Report FL #: 10088 for Greenheck models EHH-601D & ESD-635D (both w/ and w/o VCD-40 Damper)

Report FL #: 10093 for Airolite models SCH601MD & K6746MD (both w/ and w/o VCD-40 Damper)

APPROVAL DOCUMENT: Drawing No. **K6746MD**, titled "K6746MD Louver", sheets 1 through 37 of 37, dated 08/09/2017, prepared by The Airolite Company, signed and sealed by Wayne K. Helmila, P.E. on 08/19/2024 and 09/27/2024, bearing the Miami-Dade County Product Control revision stamp with the Notice of Acceptance number and expiration date by the Miami-Dade County Product Control Section.

PRODUCT REVISED
as complying with the Florida
Building Code
NOA-No. **24-0930.05**
Expiration Date **12/06/2029**

HEAD DETAIL W/ VCD-40
LOUVER HEIGHT ≤ 144 IN.

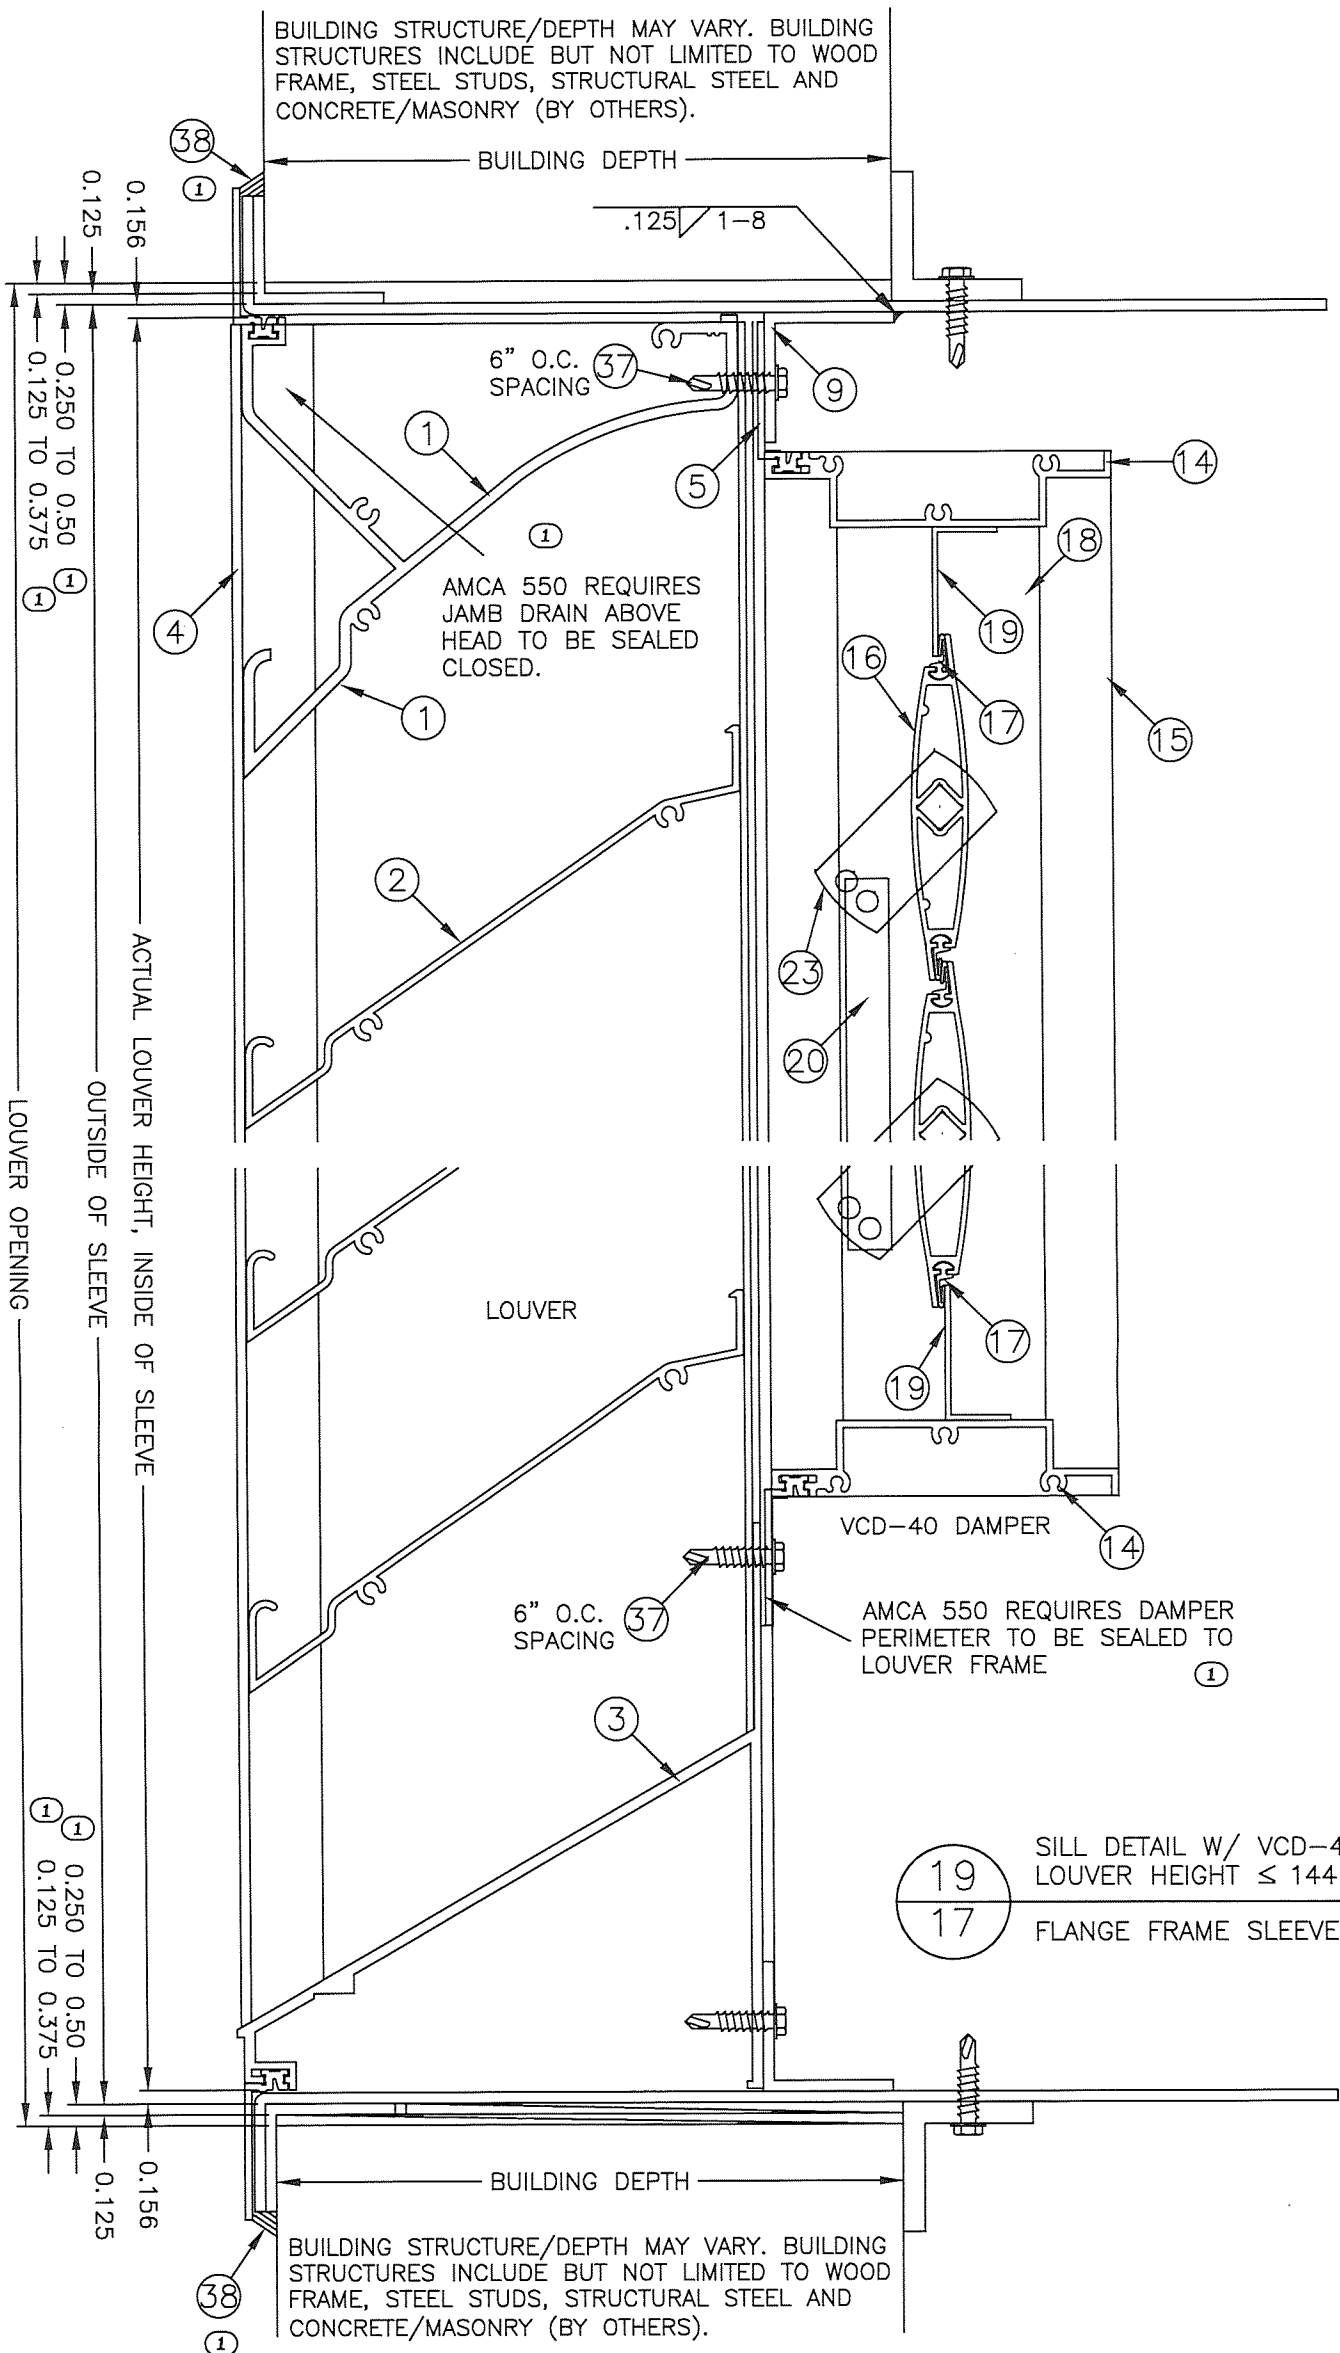
REV 01: 8/1/24, WAS PAGE 14, MOVED DETAILS 20 & 21 TO A NEW PAGE, REMOVED "TYP" FROM EDGE GAP X4, ADDED ITEM 38 X2, & ADDED AMCA 550 NOTE X2.

DRAWN BY MES	DATE 8/9/2017
SCALE	
SHEET NO. 18 OF 37	
CAD DRAWING NO. K6746MD

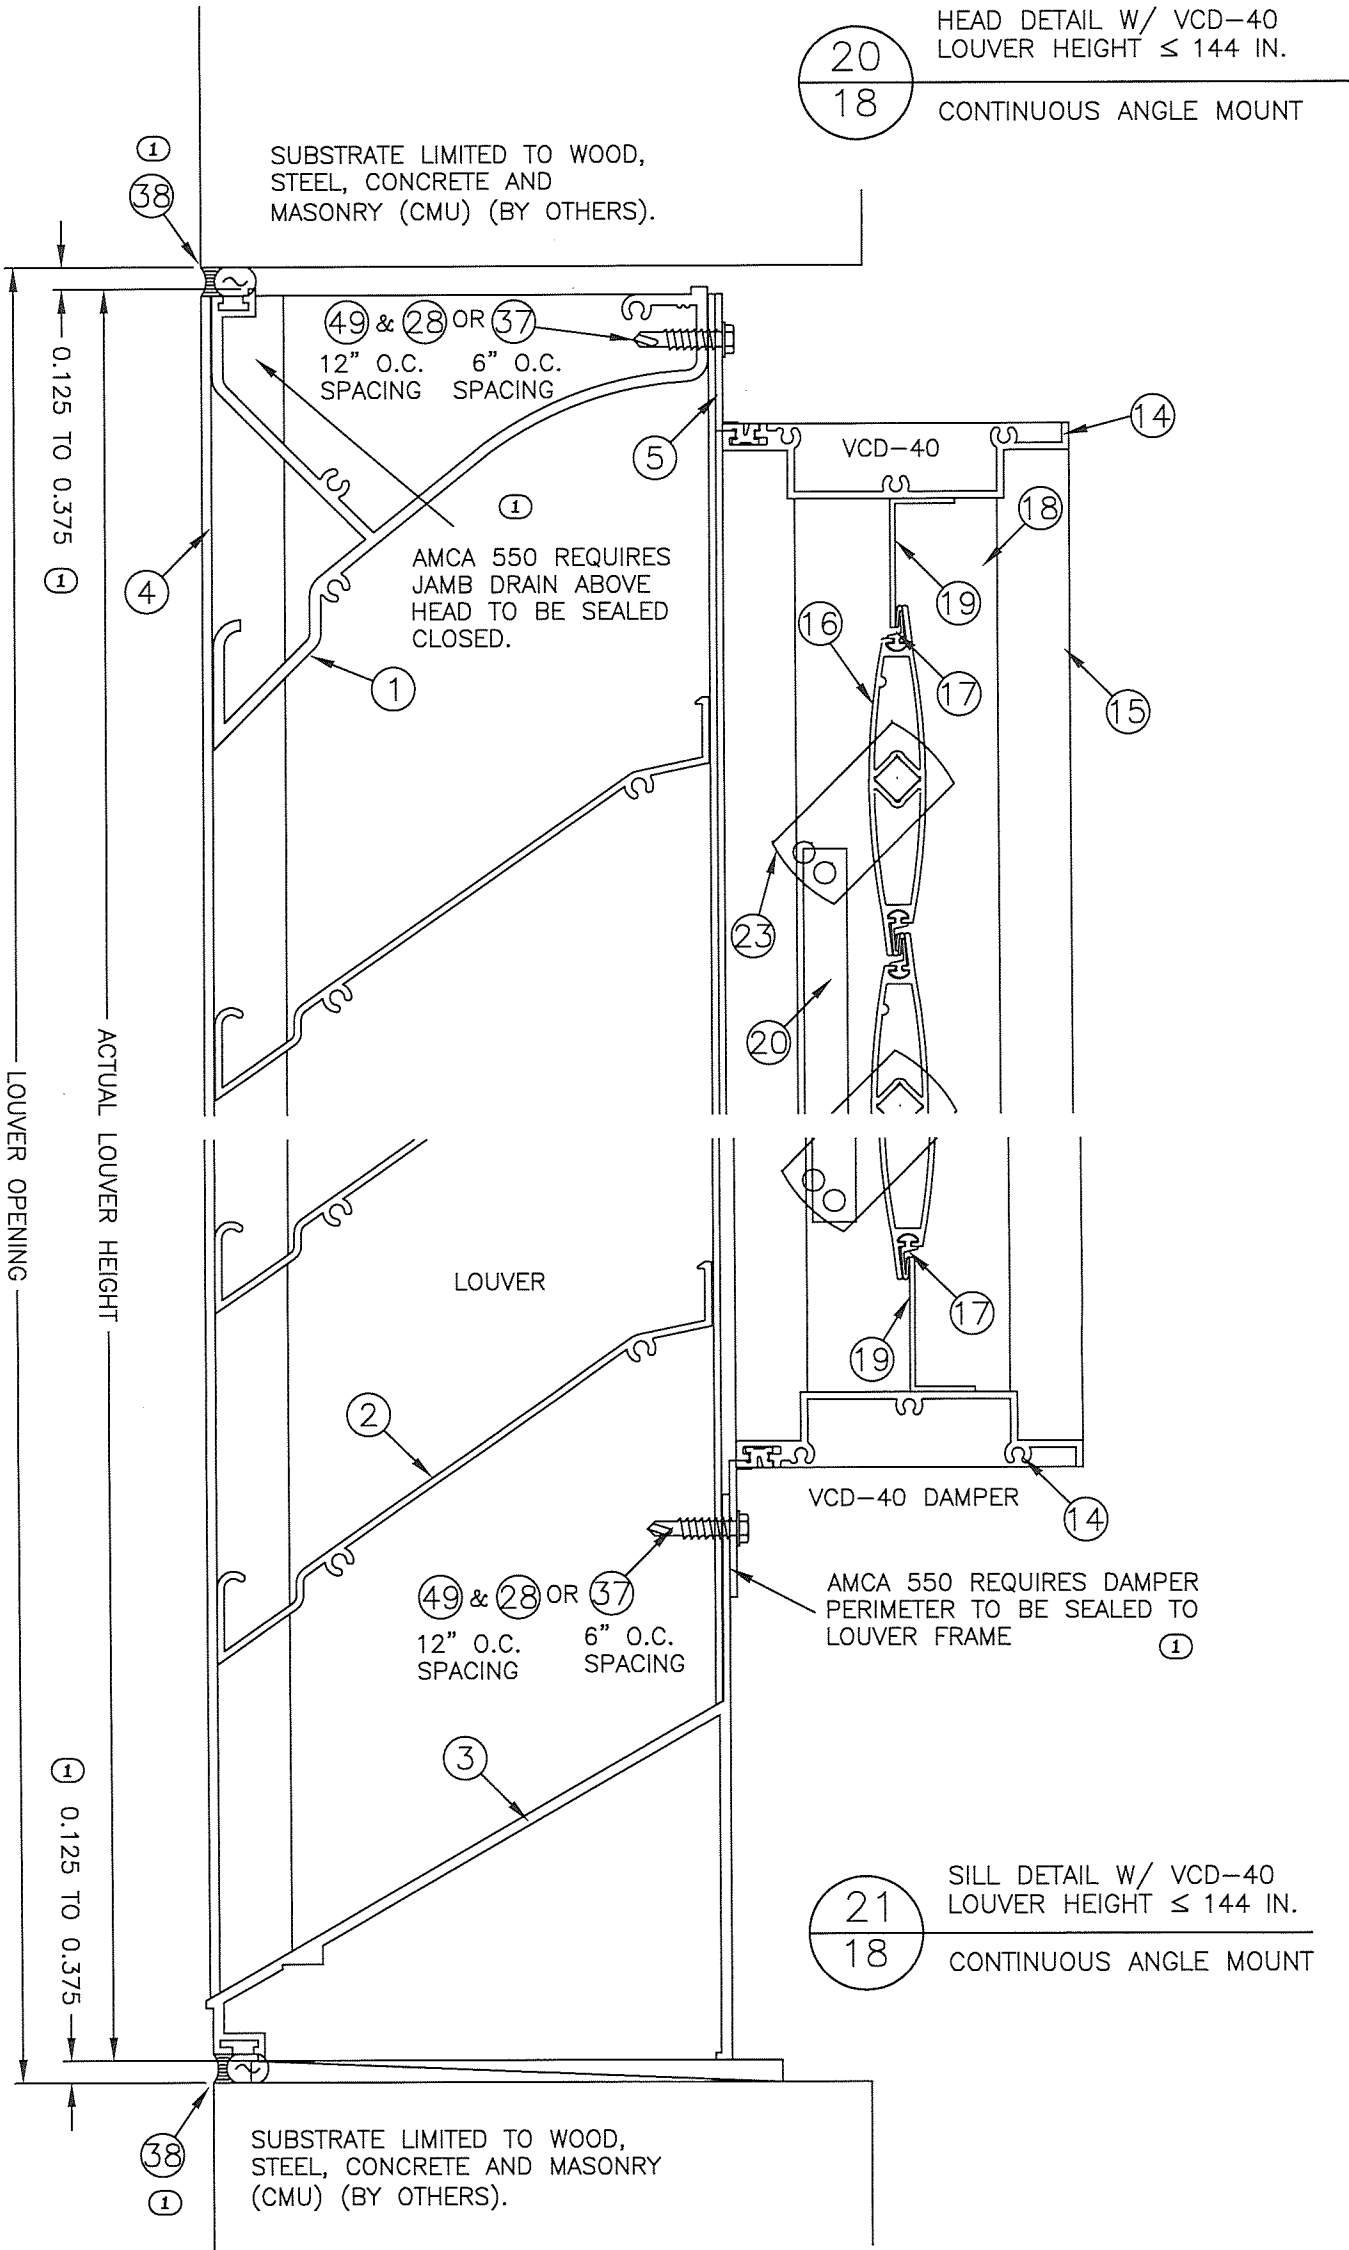
REV 01: 8/1/24, MOVED DETAILS 20 & 21 TO THIS NEW PAGE, REMOVED "TYP"
FROM EDGE GAP X2, ADDED ITEM 38 CALLOUT X2, & ADDED AMCA 550 NOTE X2.

AIROLITE SCHOFIELD, WISCONSIN 54476 715-359-6171	DRAWN BY	DATE
	MES	8/9/2017
TITLE K6746MD LOUVER W/VCD-40 FLANGE FRAME SLEEVE MOUNT JAMB DETAILS H≤144"	SCALE	
	SHEET NO.	20 OF 37
CAD DRAWING NO.		K6746MD

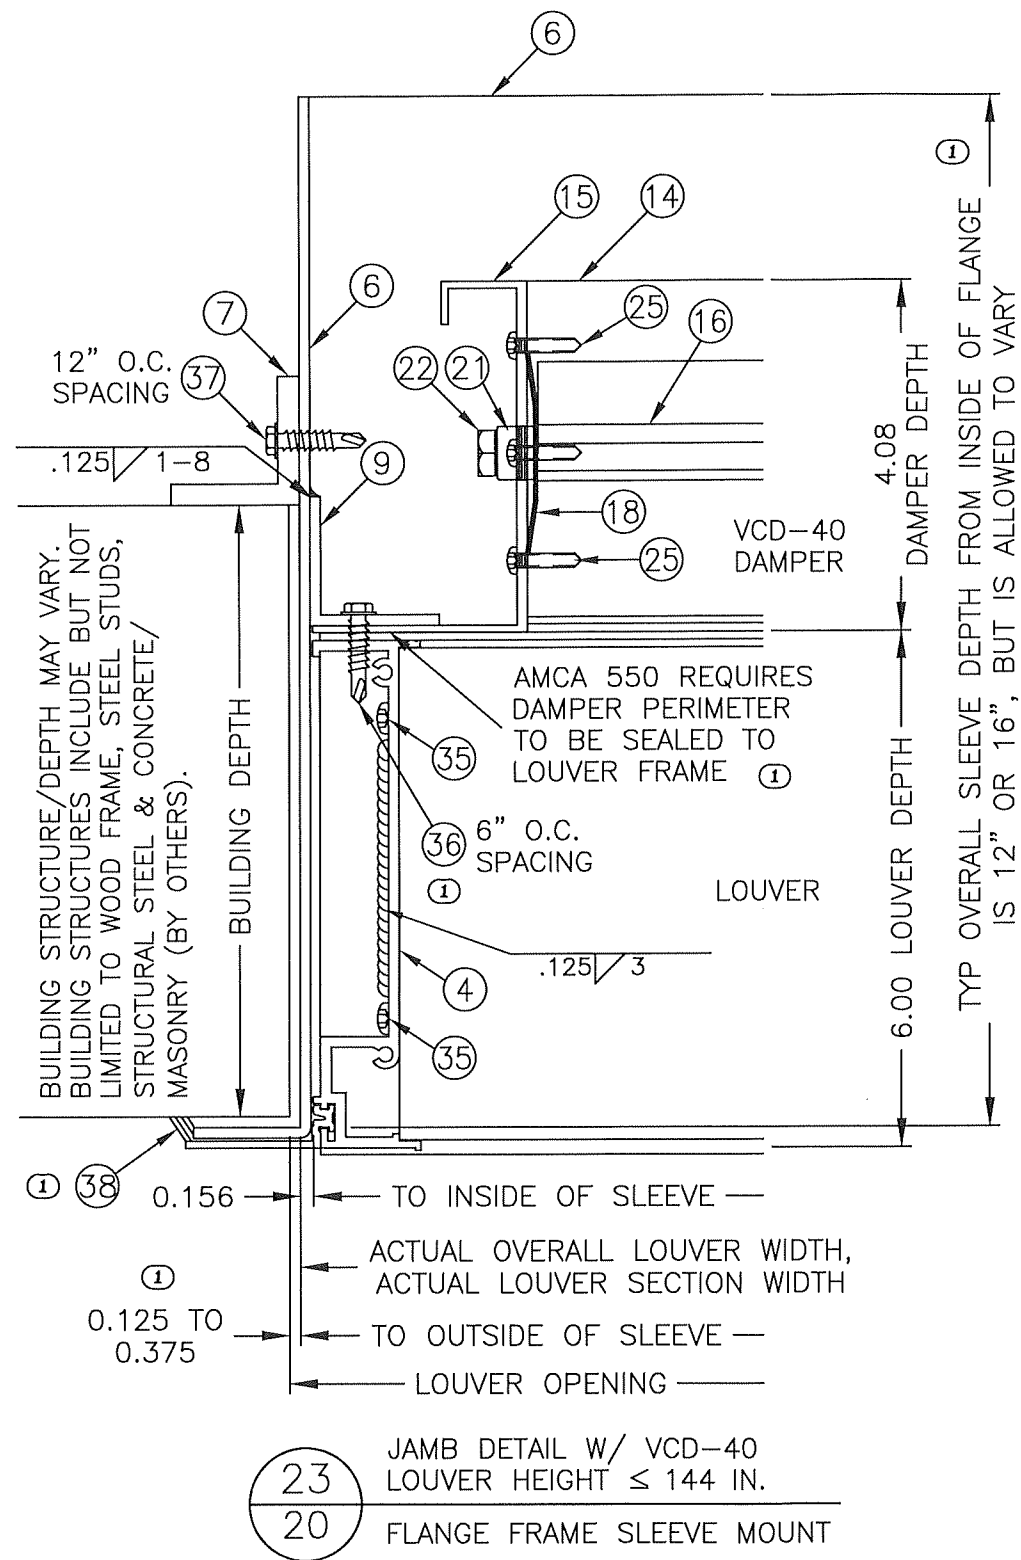
REV 01: 8/1/24, WAS PAGE 16, MOVED DETAILS 24A&B TO A NEW PAGE, REPLACED ITEM 37 WITH ITEM 36, ADDED SLEEVE DEPTH DIM, ADDED ITEM 38, REMOVED "TYP" FROM EDGE GAP, & ADDED AMCA 550 NOTE.

DRAWN BY: MES
DATE: 8/9/2017
SCALE:
SHEET NO.: 21 OF 37
CAD DRAWING NO.: K6746MD

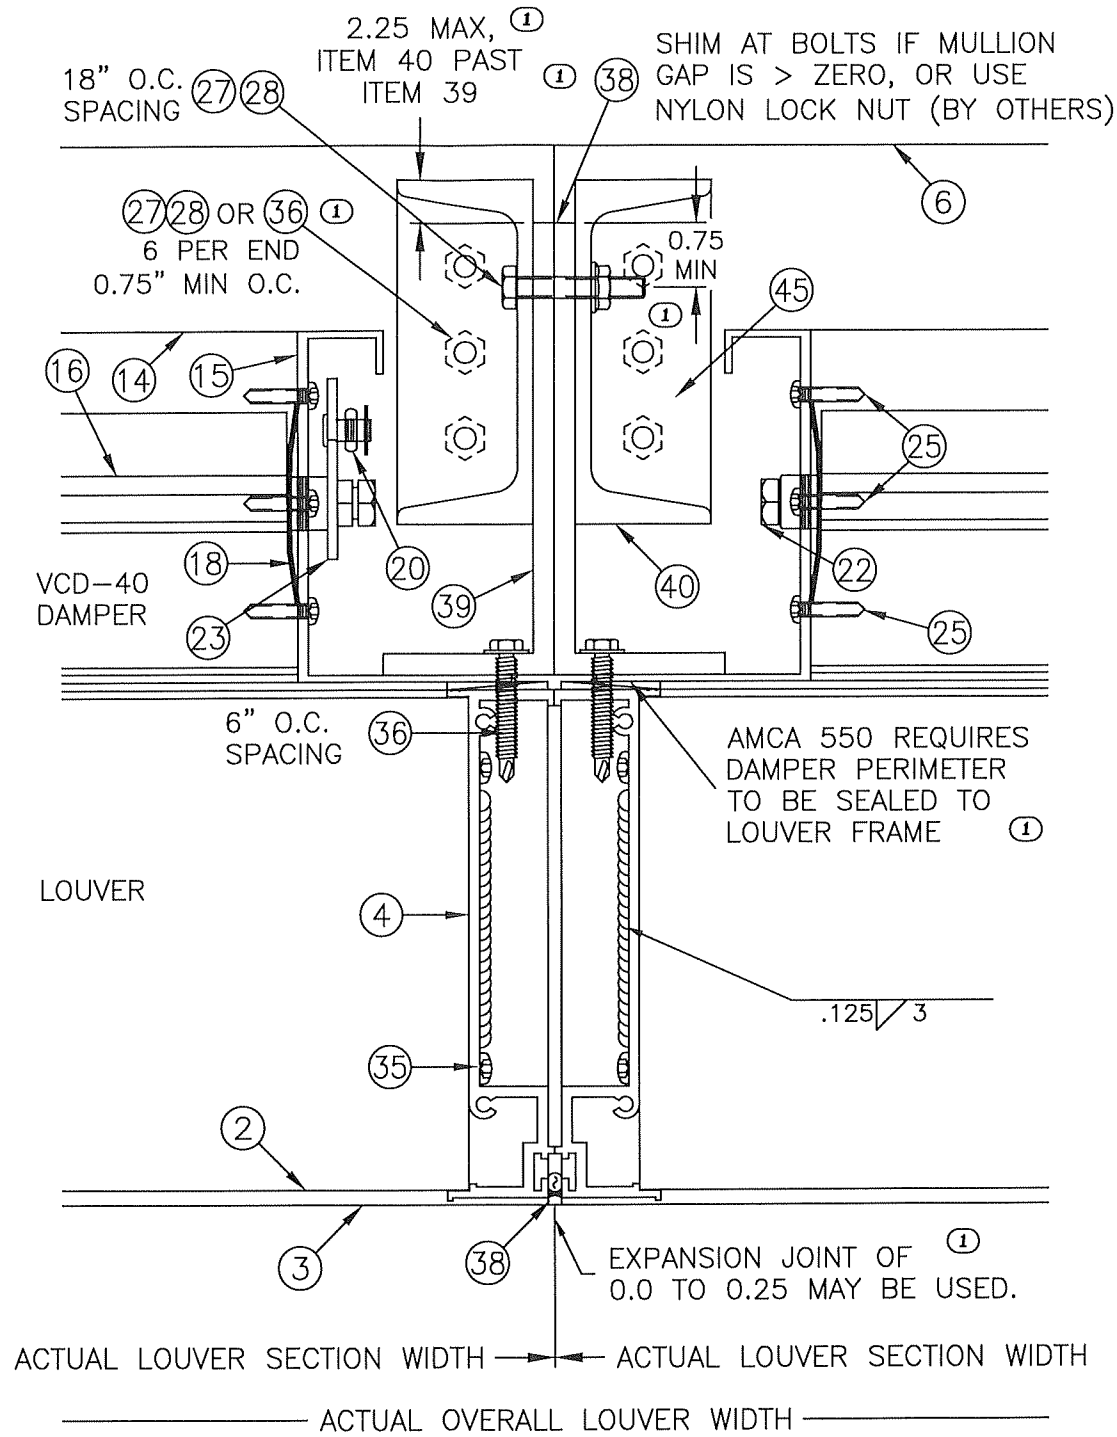
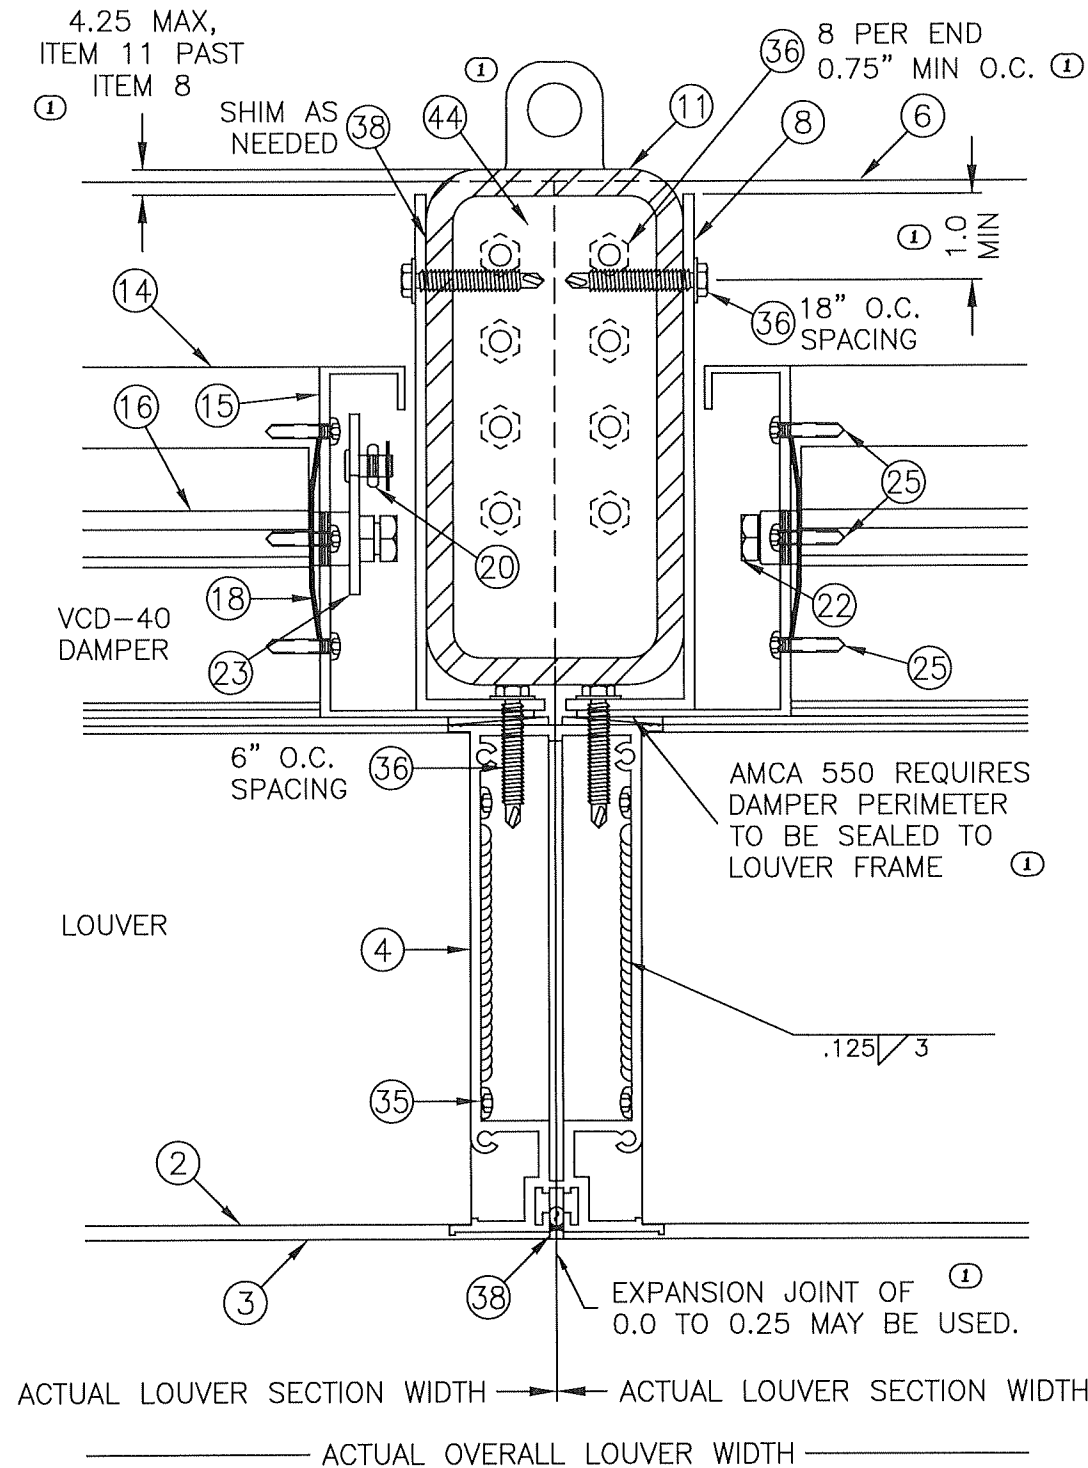
REV 01: 8/1/24, MOVED ITEMS 24A&B TO THIS NEW PAGE, REDEFINED ITEM 11 & 40 OFFSETS, ADDED 1.0 & 0.75 MIN OFFSETS, ADDED LUG TO ITEM 11, ADDED ITEM 38 CALLOUT & NOTE, ADDED MIN O.C. FOR ITEM 36, ADDED ITEM 27/28 CALLOUT WITH ITEM 36 OPTION, REWORDED MULLION GAP NOTE X2, & ADDED AMCA 550 NOTE X2.
